RE: 1105 Front Street NE – The Cannery (Reference No. 24-106451-PLN) Completeness Response

Reference Nos.: 24-106451-PLN (Class 3 Site Plan Review, Tentative Subdivision Plan, Class 1 & 2 Adjustment, Class 2 Driveway Approach Permit)

PRELIMINARY SITE PLAN
THE CANNERY
FUND
SALEM, OREGON

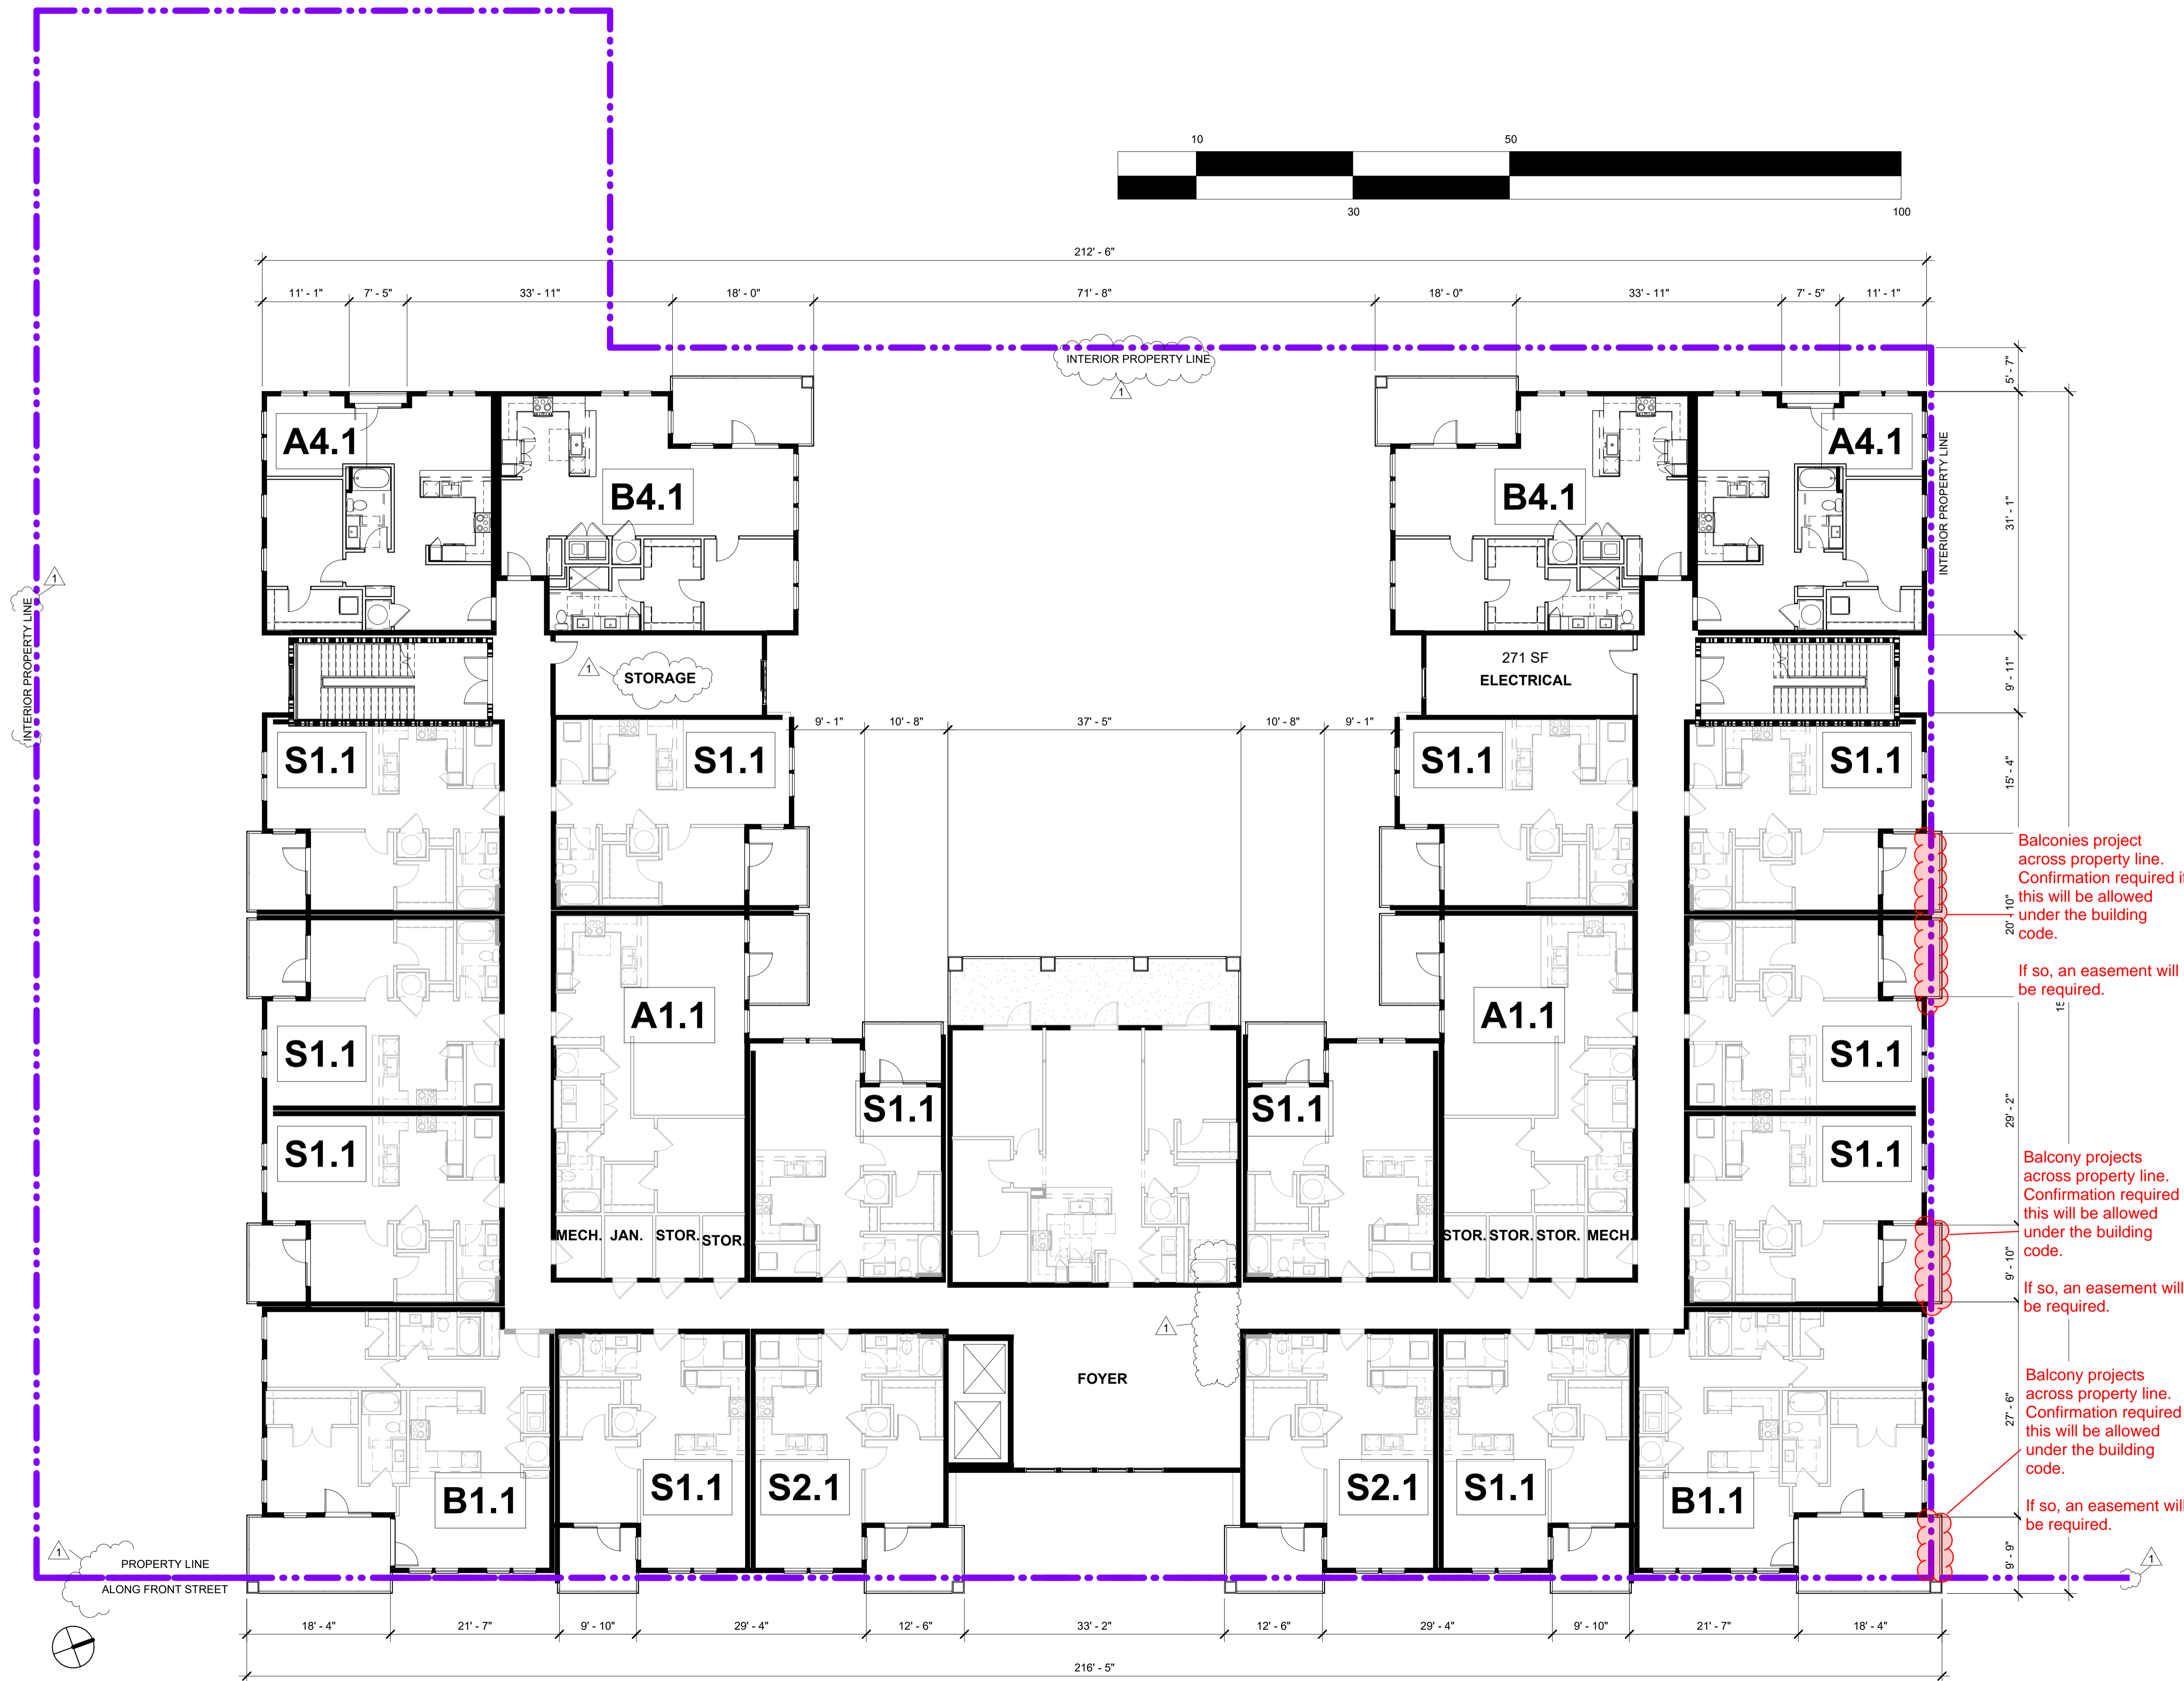
Balconies project across property line. Confirmation required if this will be allowed under the building code.

If so, an easement will be required.

Response: Planned property lines have been modified such that no canopies, balconies, or living space project across a property line as detailed on the revised Preliminary Building Elevations and Floor Plans in Attachment E. The 6th floor living space that projected into the Front Street NE right-of-way has been modified. This item is met.

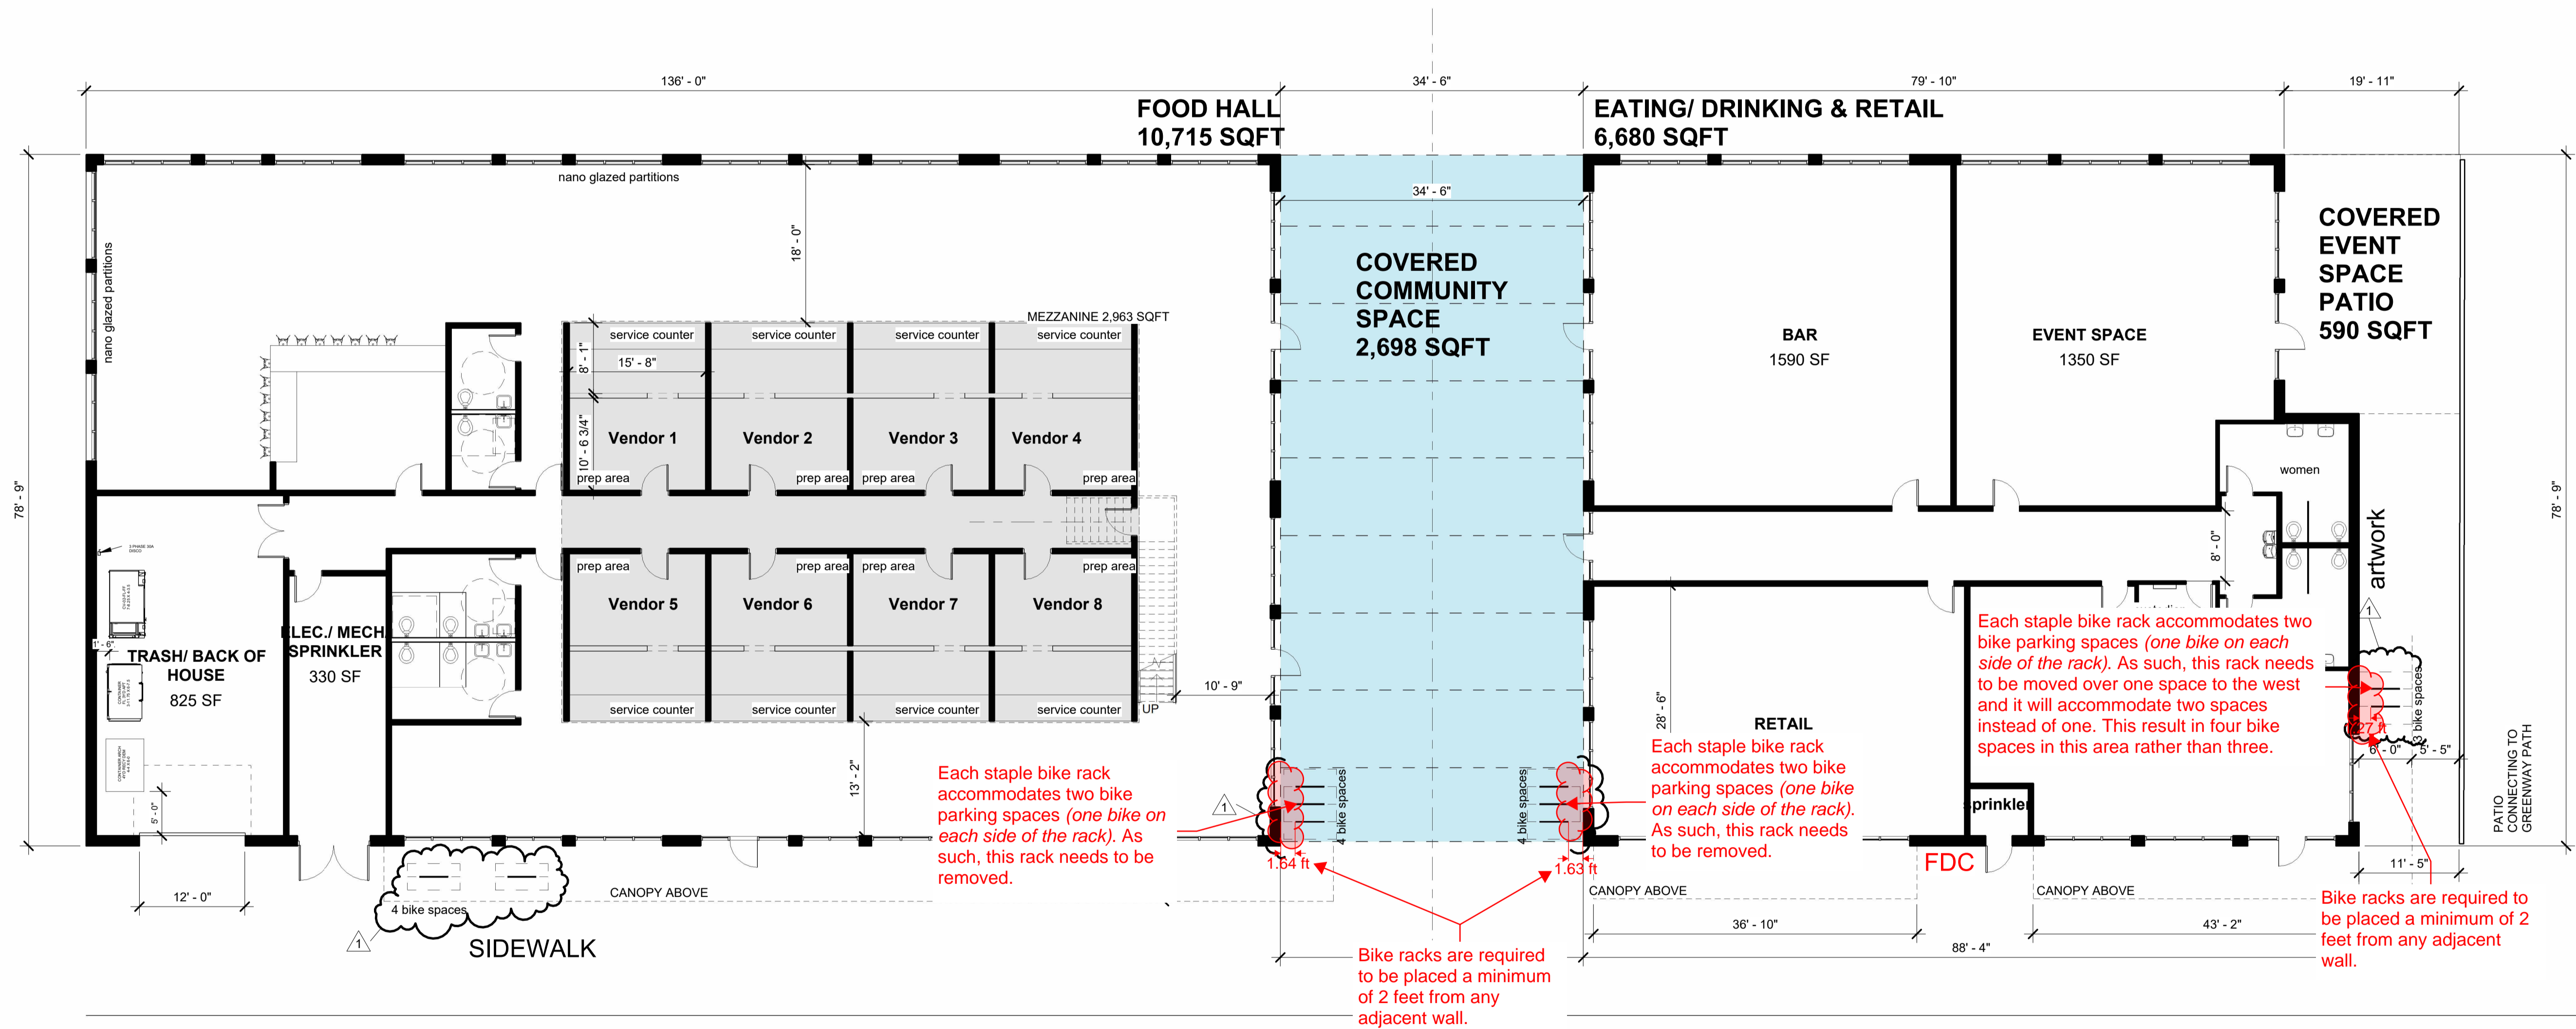
Public Works will not allow living space to project into the public street right-of-way.

If the building code will allow this portion of the building to project across the north property line, an easement will be required.

Living space of dwelling unit projects into public right-of-way. Public Works will not allow living space to project into the public street right-of-way.
